Rivett Section 28 Block 13

Stormwater Investigation

From: Neilsen, Andrew
Sent: Tuesday, 11 November 2014 2:45 PM
To: Carson, Lucia
Subject: Ahmaddiya Muslim Association Australia Limited

RIVETT SECTION 28 BLOCK 13
OPTION TO ACCOMMODATE
OVERLAND FLOW

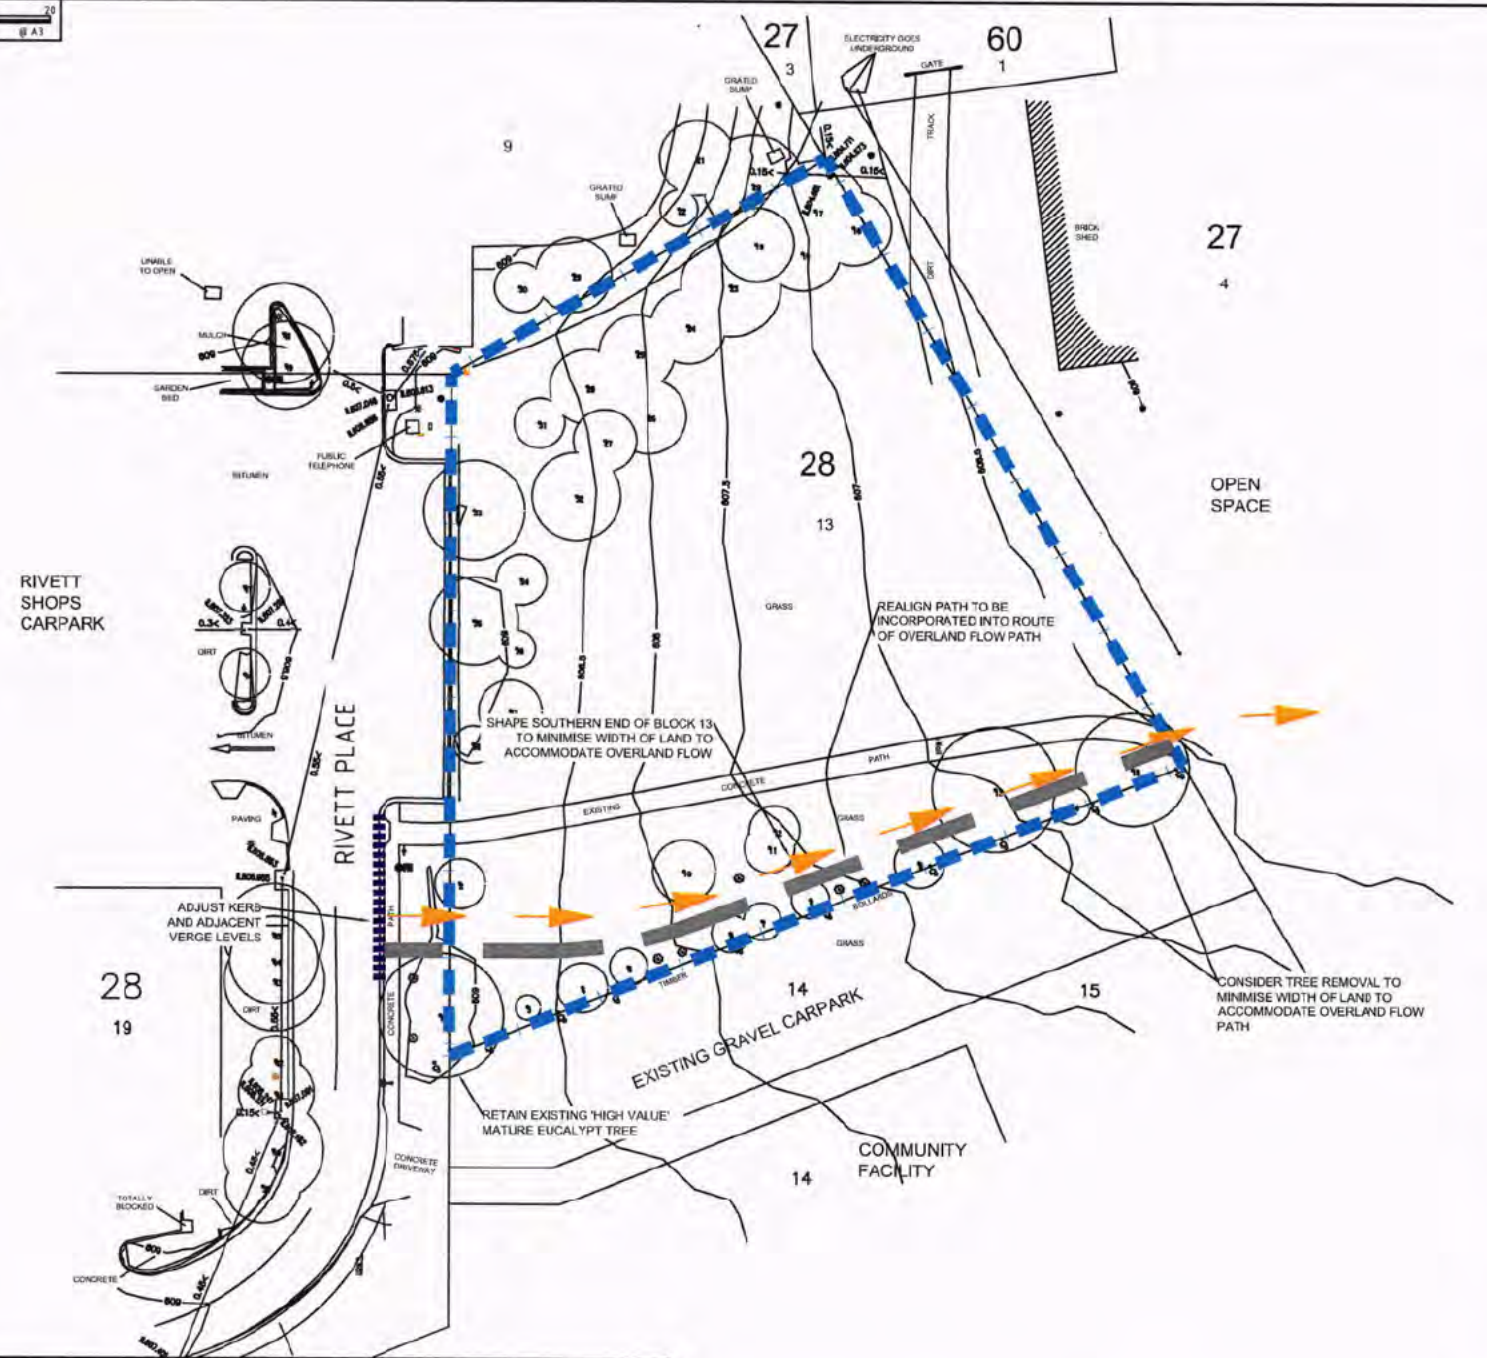
- TAMS have requested a path on the northern side of the block and a path on the southern side of the block (Frank Yu email 30 April 2014), it would be reasonable to discuss whether both paths are required as this reduces developable land.
- Have not seen a response back to LDA from Frank Yu in relation TAMS Tree Section comment on proposed northern path in vicinity of existing trees (Frank Yu email 27 May 2014).
- There are also trees located within the block which will be in the vicinity of the realigned southern path.

The overland flow report was not yet been submitted to TAMS because it thought it would be best to see what the response was from TAMS Tree Section on the northern path and tree implications. Unfortunately at this stage it appears that TAMS have not yet responded to your office so best to convene a meeting to lay all these issues on the table for discussion.
